# Technical Service Bulletin

<b>Date:</b> 10/29/2024	<b>Editor:</b> Jackie Olson	<b>Form ID:</b> TSB24002 Compartment Step Weight Limit Label
----------------------------	--------------------------------	---

<b>Component</b>	Engine compartment fold-down steps
<b>Apparatus type</b>	Rosenbauer Panther
<b>Affected apparatus</b>	2018 & Newer A144/A146

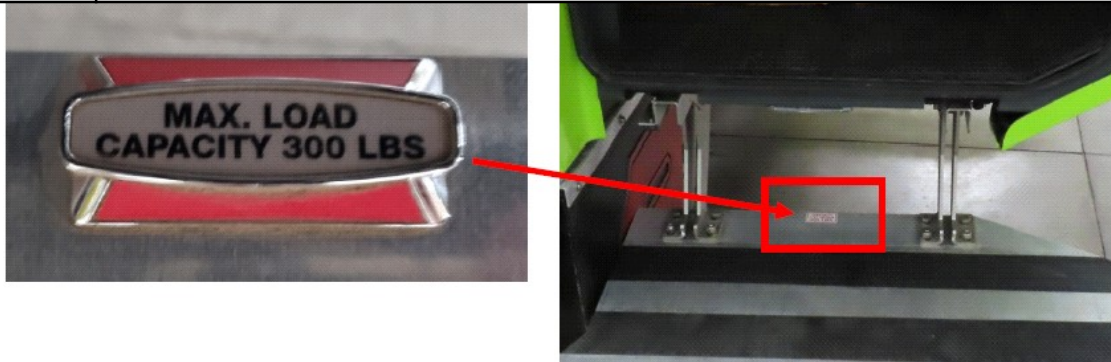
<b>Issue</b>	A missing weight limit label on certain step compartments has led to instances where users may have unknowingly exceeded the recommended weight capacity, resulting in damage to the step.
<b>Cause</b>	Label missed during production of ARFF product
<b>Priority Level</b>	High

<b>Correction</b>	If your apparatus is missing these weight limit decals, please apply one label to the back of each fold down step, as seen in the photo.
-------------------	--
